# Modification of Development Consent

<b>Development consent:</b>	06_0228
<b>Applicant:</b>	Shoalhaven Starches Pty Ltd
<b>Consent Authority:</b>	Minister for Planning and Public Spaces
<b>Development:</b>	Shoalhaven Starches Expansion Project
<b>Date of original approval:</b>	29 January 2009
<b>Modification:</b>	06_0228 MOD 17 - relocation of the approved No.5 Starch Dryer baghouse, installation of a service lift, alterations to the Specialty Products Building and Product Dryer Building including increase of building footprint, elevation of service conduit and alternative woodchip fuel source for Boilers 2 and 4.

**End of modification  
(06\_0228 MOD 17)**

MOD 17 – Site Plan

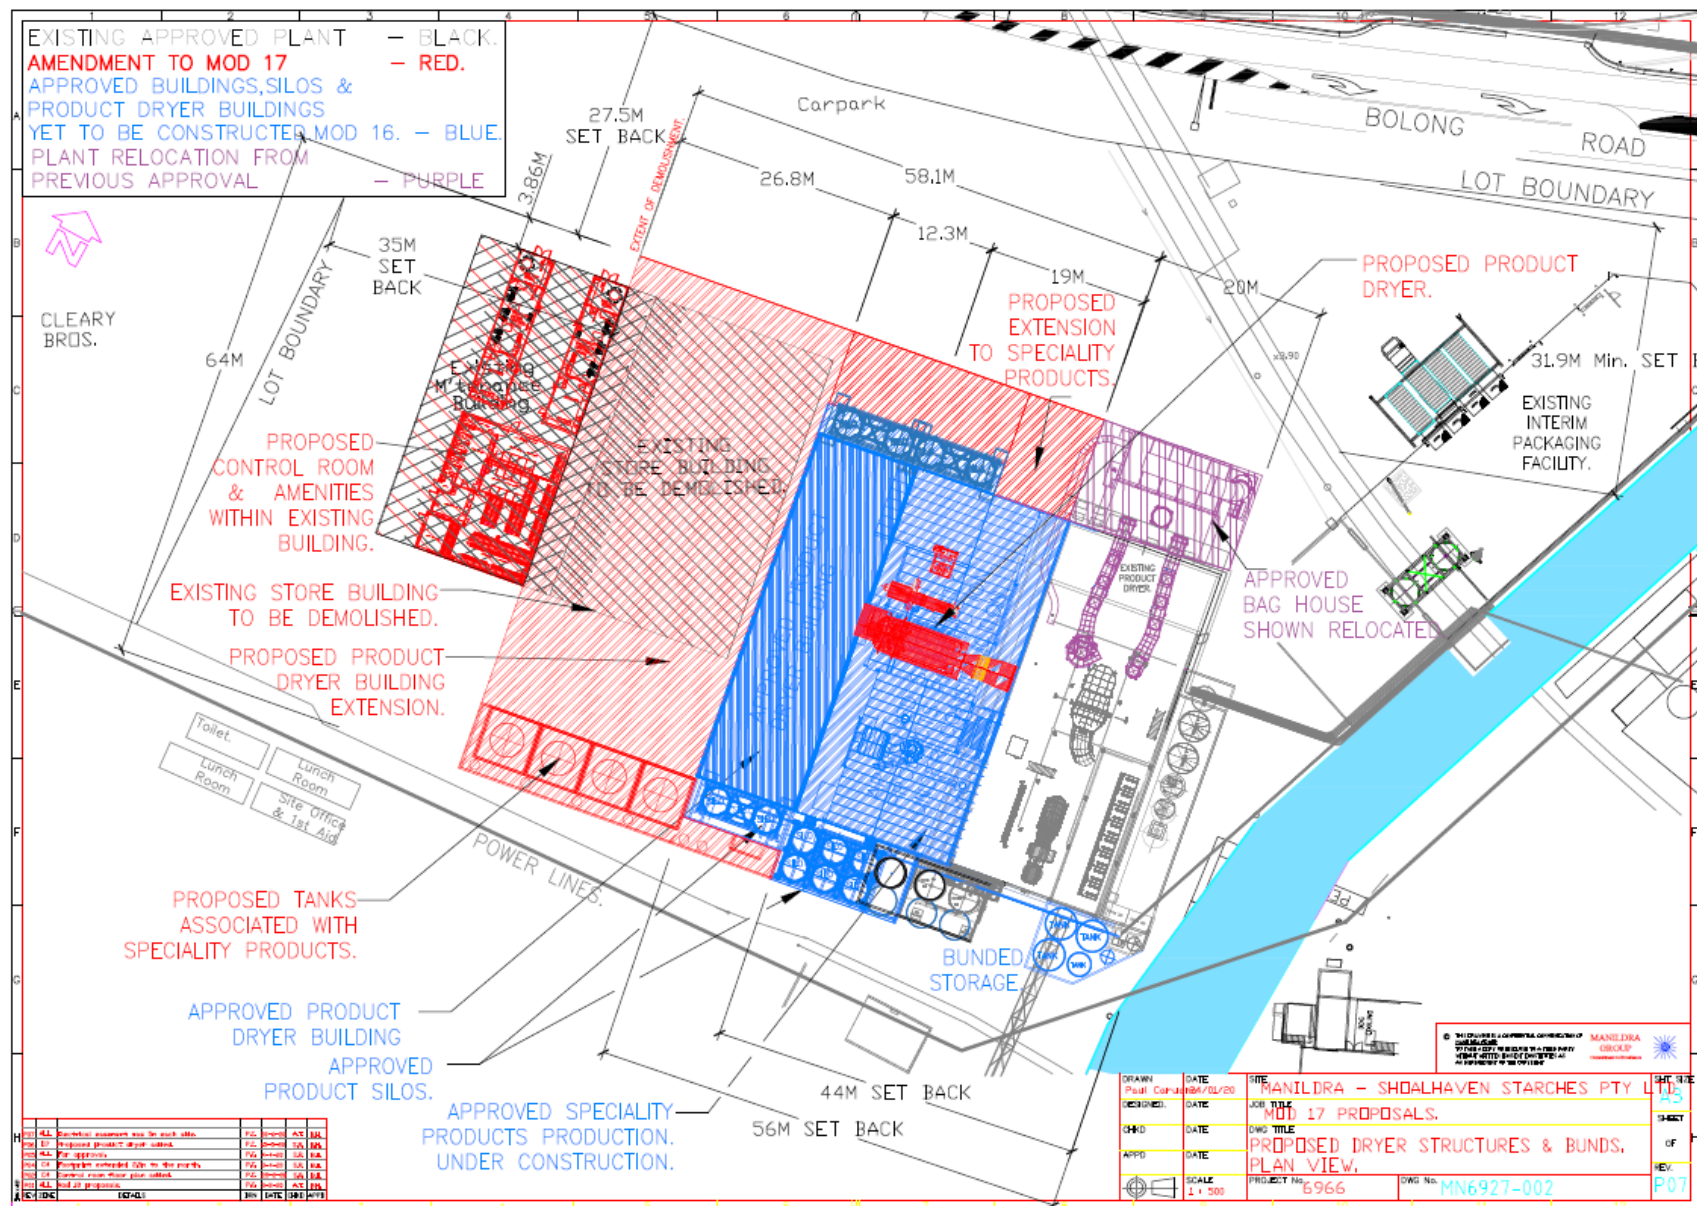
- r) modification application 06\_0228 MOD 17, accompanying Statement of Environmental Effects dated 13 December 2019, prepared by Cowman Stoddart Pty Ltd, Addendum Statement of Environmental Effects dated 19 June 2020, RtS dated 28 July 2020 and the accompanying amended plans (see Appendix 2R).
